PRAIRIE ISLAND NUCLEAR GENERATING PLANT, UNIT NO. 1

AMENDMENT TO FACILITY OPERATING LICENSE

Amendment No. 89
License No. DPR-42

ATTACHMENT TO LICENSE AMENDMENTS NOS. 82 AND 89
FACILITY OPERATING LICENSES NOS. DPR-42 AND DPR-60
DOCKETS NOS. 50-282 AND 50-306

FIGURE TS 3.1-1

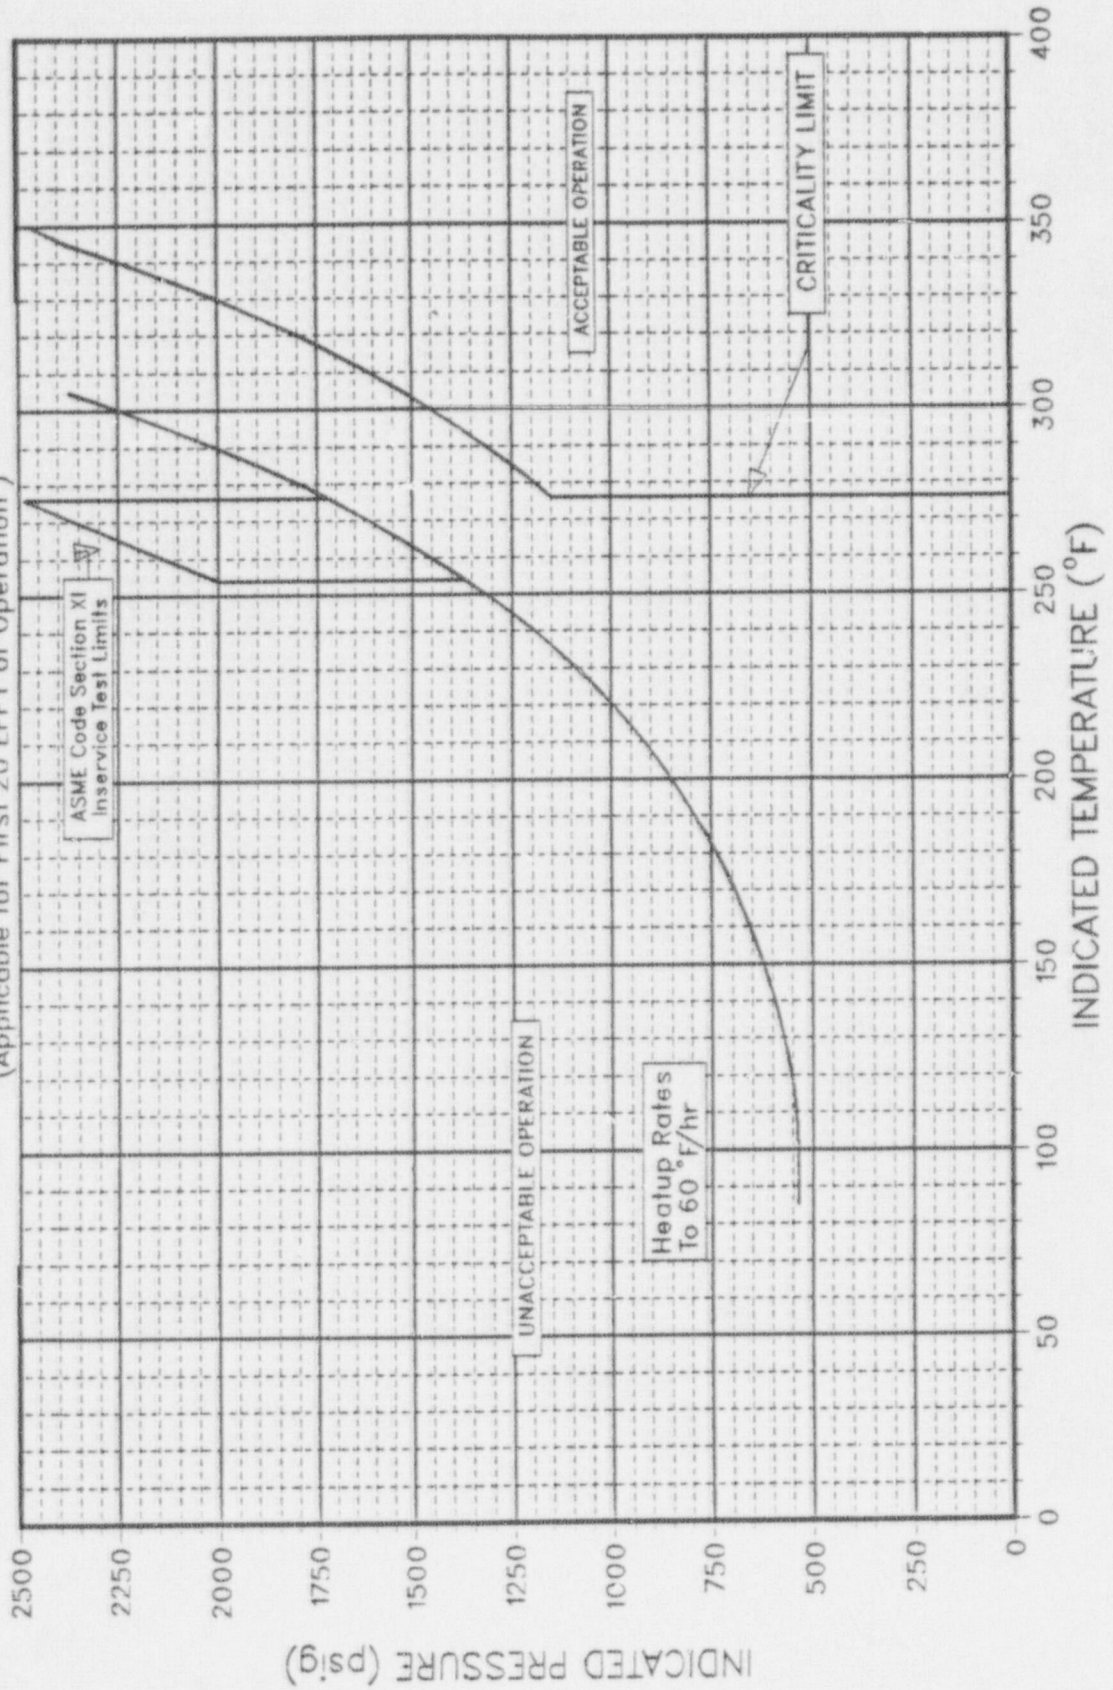
1. The Unit 1 and Unit 2 reactor coolant temperature and pressure and system heatup and cooldown rates (with the exception of the pressurizer) shall be limited in accordance with Figures TS.3.1-1 and TS.3.1-2.

- a. Allowable combinations of pressure and temperature for specific temperature change rates are below and to the right of the limit lines shown. Limit lines for cooldown rates between those presented may be obtained by interpolation.

- b. Figures TS.3.1-1 and TS.3.1-2 define limits to assure prevention of non-ductile failure only. For normal operation other inherent plant characteristics, e.g., pump heat addition and pressurizer heater capacity may limit the heatup and cooldown rates that can be achieved over certain pressure-temperature ranges.

2. The limit lines shown in Figures TS.3.1-1, TS.3.1-2 shall be recalculated periodically using methods discussed in the Bases section.
3. The secondary side of the steam generator must not be pressurized above 200 psig if the temperature of the steam generator shell is below 70°F.
